Mesa 500-kV Substation Project CPUC Minor Project Change Form

Report No.: 08

MINOR PROJECT CHANGE EIGHT

RE: Mesa 500-kV Substation Project – Minor Project Change No. 8 Request: Telecom Conduit Undergrounding

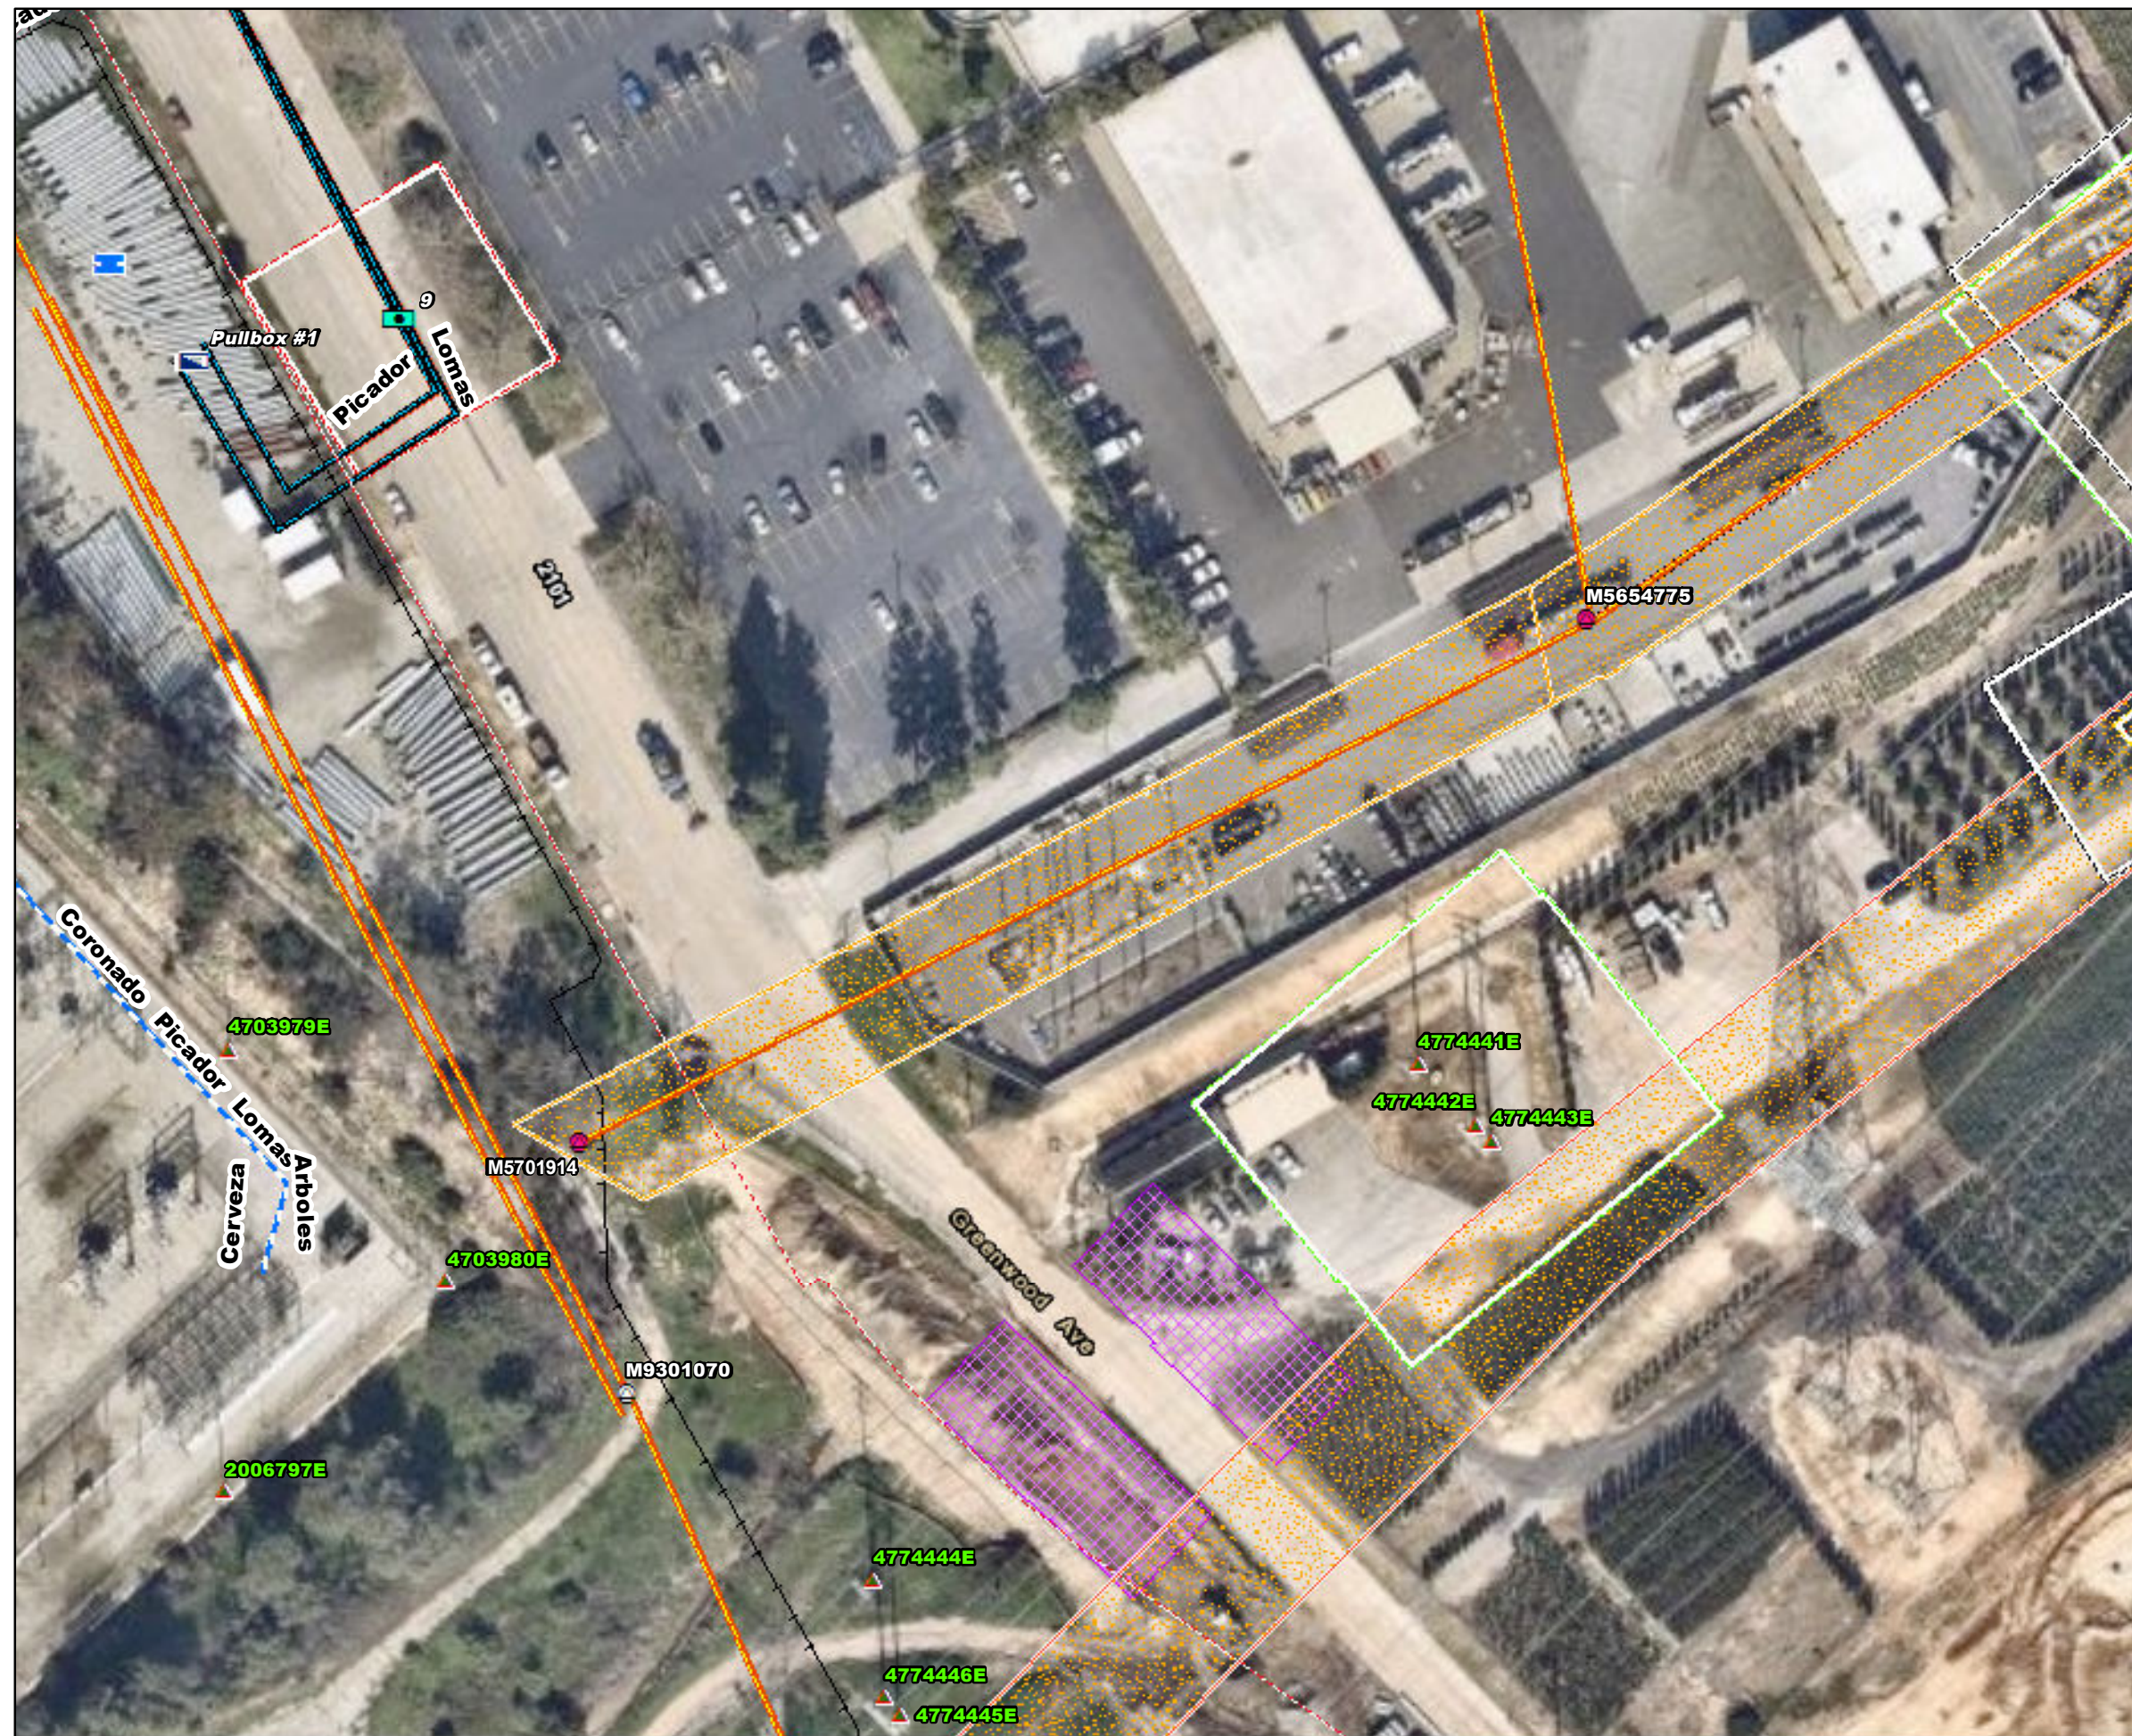
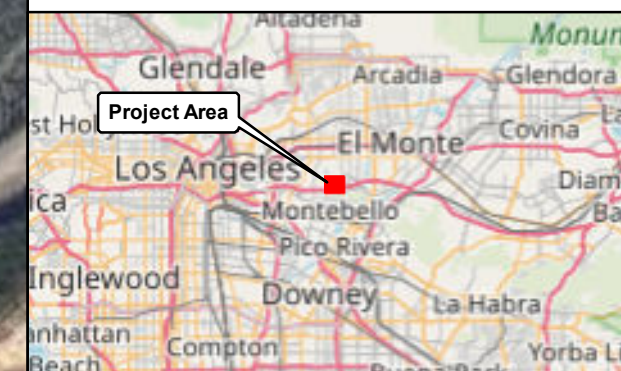
- **Original Condition:** The original, approved project included the installation of new communications cables in an existing conduit between the existing manhole on the substation site (M9301070; west end) and the existing manhole in the Service Center parking lot (M5654775; east end). This line passes under **Marketplace Drive** (formerly Greenwood Ave.) During grading activities of the substation site, the existing manhole (M9301070; Photo 1) was damaged, so a new manhole (M5701914) closer to the street was proposed to take its place and connect to the existing conduit. When the old cabling was being removed, the crews found that the existing conduit was blocked, so much so that the cable ripped apart as it was being removed. Subsequent investigation found two separate blockages roughly 30 feet apart from each other in the middle of **Marketplace Drive**. It is presumed that the conduit is collapsed due to the excessive reconstruction of **Marketplace Drive** during the recent development of the Monterey Park Marketplace shopping center. Based on the probable negative impacts to **Marketplace Drive**, and traffic, to find and repair the blockage(s), thereby creating a more obvious street cut to the pavement of **Marketplace Drive**, the Project team decided that it would be more efficient, and provide more future flexibility, if two new 5-inch conduits were installed and a straighter cut (Photo 2) could be made across **Marketplace Drive**.

For these reasons, SCE proposes to install approximately 500-feet of two new 5-inch conduits between the existing manhole on the east side (M5654775; within the SCE Service Center parking lot) and a new manhole on the west side (M5701914; behind the future substation perimeter wall) which passes under **Marketplace Drive**. The trench on **Marketplace Drive** for this undergrounding will be approximately 2 feet wide and approximately 5 feet deep. Soil will be stockpiled adjacent to the trenching on **Marketplace Drive**, and the trenches will be backfilled with the soil when the construction is complete. Equipment used to install these conduits and the new manhole will be similar to equipment that has already been used for similar activities on the project (backhoe, small crane, etc.). After these conduits are installed under **Marketplace Drive**, the existing conduit from the west side of Marketplace Drive into the SCE Service Center will be abandoned in place, while the portion of that conduit continuing to the west, as well as the existing (damaged) manhole, will be removed as part of the overall site grading activities.

- Justification for change: The addition of new telecommunications conduits described above is proposed so the project will be able to re-establish a viable path for telecommunications cables under **Marketplace Drive** to be installed to the newly constructed Operations Building from their source location across **Marketplace Drive** in the SCE Service Center.
- Figure and Photos: Attached to this document.
 - Figure. Telecommunications Conduit Undergrounding in the Area of **Marketplace Drive**, 600' South of Potrero Grande Avenue.
 - Numbered photos attached.
- Environmental Impact:

MINOR PROJECT CHANGE EIGHT

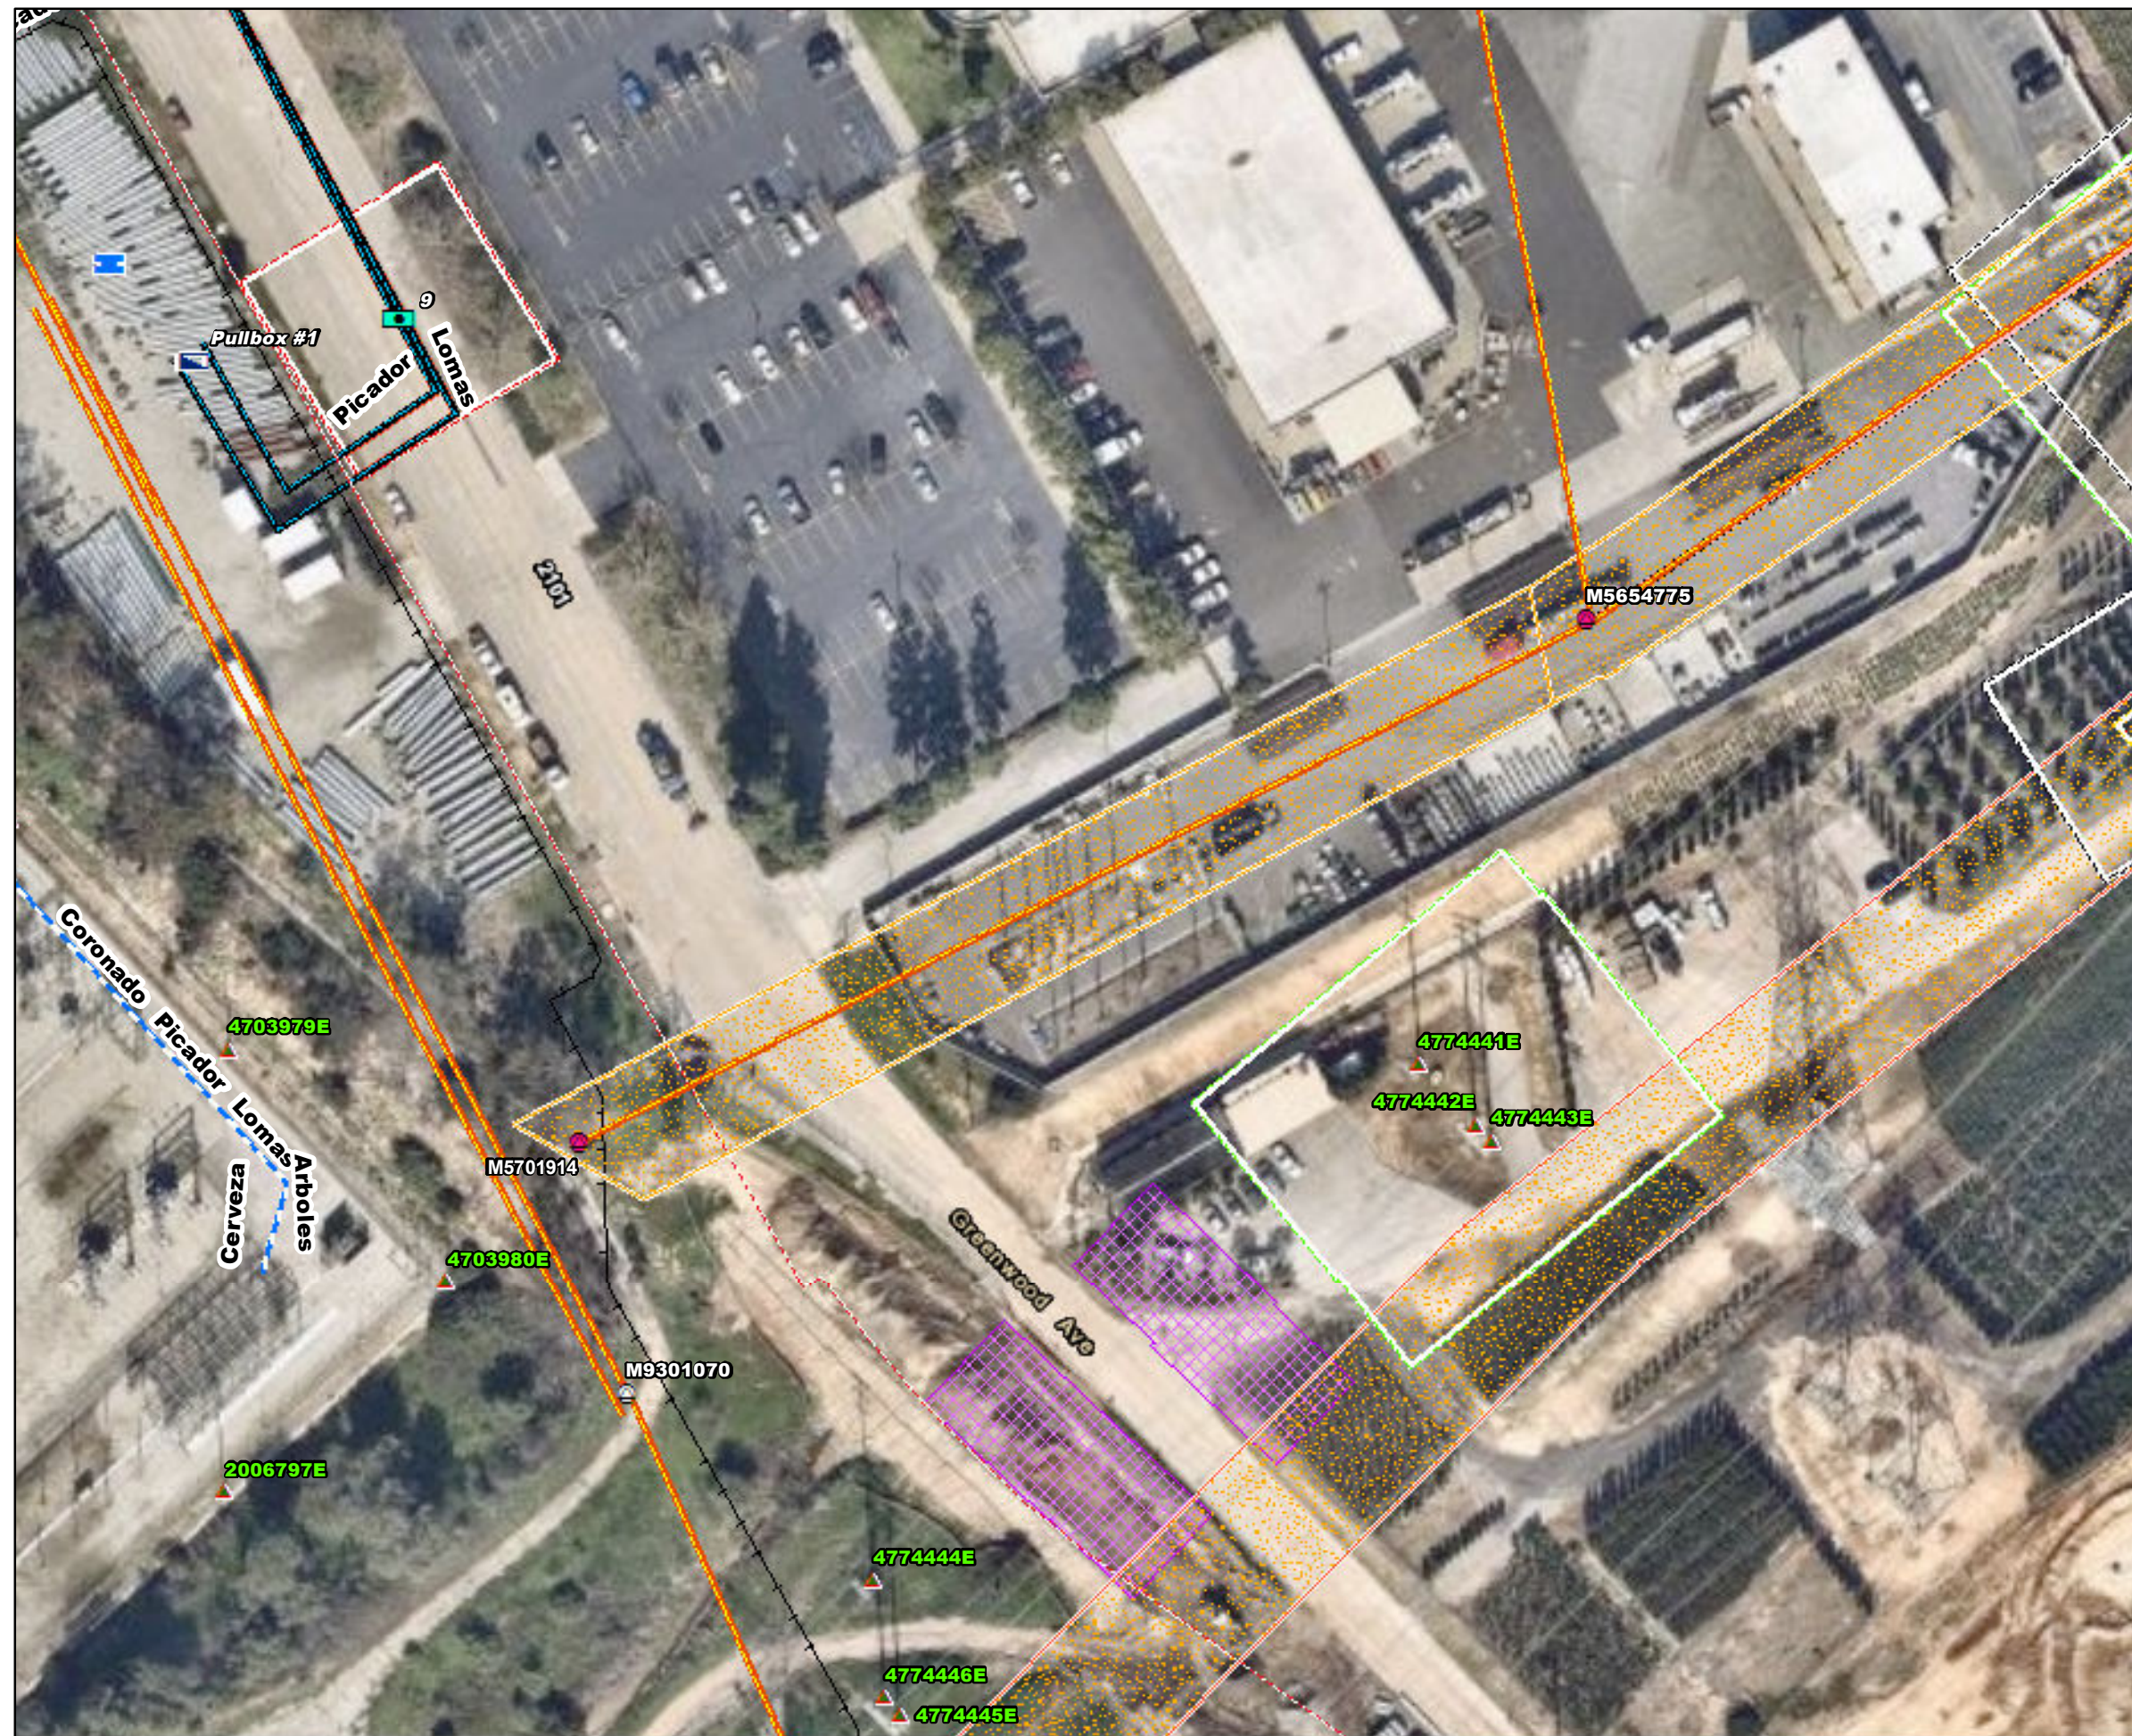
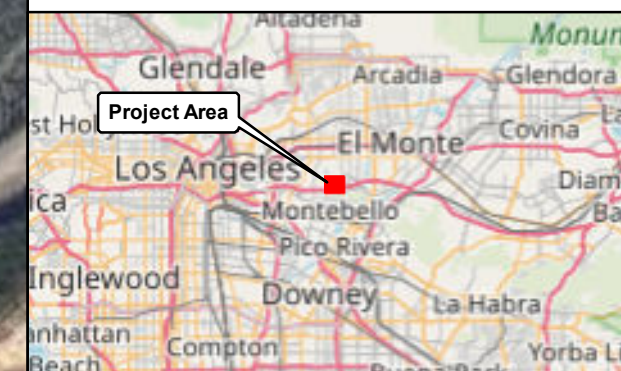
On August 23, 2019, Southern California Edison (SCE) submitted Minor Project Change (MPC) No. 8 Request to the California Public Utilities Commission (CPUC) for review. The proposed MPC would involve installation of approximately 500-feet of two new 5-inch conduits between the existing manhole on the east side (M5654775; within the SCE Service Center parking lot) and a new manhole on the west side (M5701914; behind the future substation perimeter wall) which passes under Marketplace Drive. The trench on Marketplace Drive for this undergrounding will be approximately 2 feet wide and approximately 5 feet deep. Soil will be stockpiled adjacent to the trenching on Marketplace Drive, and the trenches will be backfilled with the soil when the construction is complete.

The installation of a new manhole and telecommunication conduits described above is proposed because damage to an existing manhole (M9301070) was found, therefore a new manhole (M5701914) closer to the street is proposed to take its place and connect to the existing conduit. Further, when old cabling was being removed, construction crews found that the existing conduit was substantially blocked, causing the cable to rip apart as it was being removed. Subsequent investigation found two separate blockages roughly 30 feet apart from each other in the middle of Marketplace Drive. It is presumed that the conduit is collapsed due to the excessive reconstruction of Marketplace Drive during the recent development of the Monterey Park Marketplace shopping center. Based on the probable negative impacts to Marketplace Drive, and traffic, to find and repair the blockage(s), thereby creating a more obvious street cut to the pavement of Marketplace Drive, SCE assessed that it would be more efficient, and provide more future flexibility, if two new 5-inch conduits were installed at a straighter cut across Marketplace Drive. Work under MPC No. 8 is critical so the project will be able to re-establish a viable path for telecommunication cables under Marketplace Drive to be installed to the newly constructed Operations Building from their source location across Marketplace Drive in the SCE Service Center.

MPC No. 8 is approved by the CPUC with conditions. The conditions presented below shall be met by SCE and its contractors:
